MILITARY SPECIFICATION SHEET

LAMPHOLDER, LIGHTS, INDICATOR (HOUSING), STYLE LH98

This amendment forms a part of MIL-L-3661/65C dated 25 October 1978 and is approved for use by all Departments and Agencies of the Department of Defense.

MIL-L-3661/65C
AMENDMENT 1

FIGURE 3. Midget screw lamp socket.

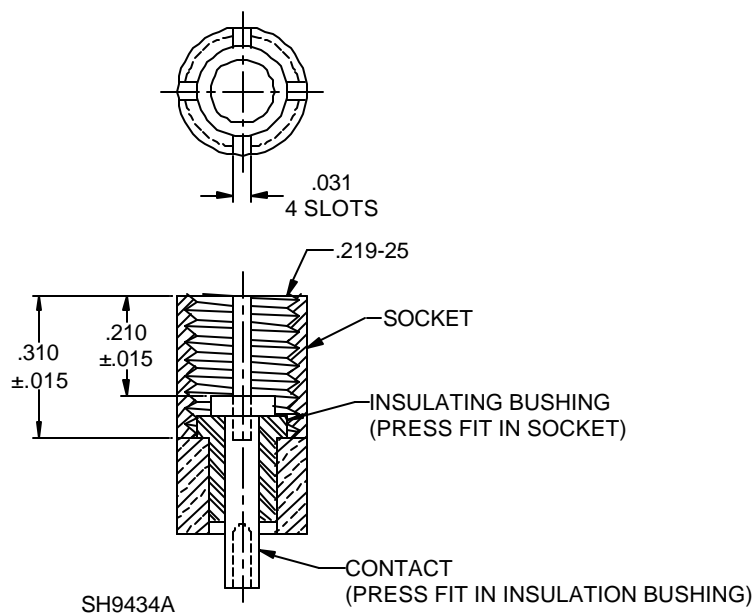
FIGURE 3: Delete and substitute:

Inches	mm
.031	0.79
.210	5.33
.219	5.56
.310	7.87
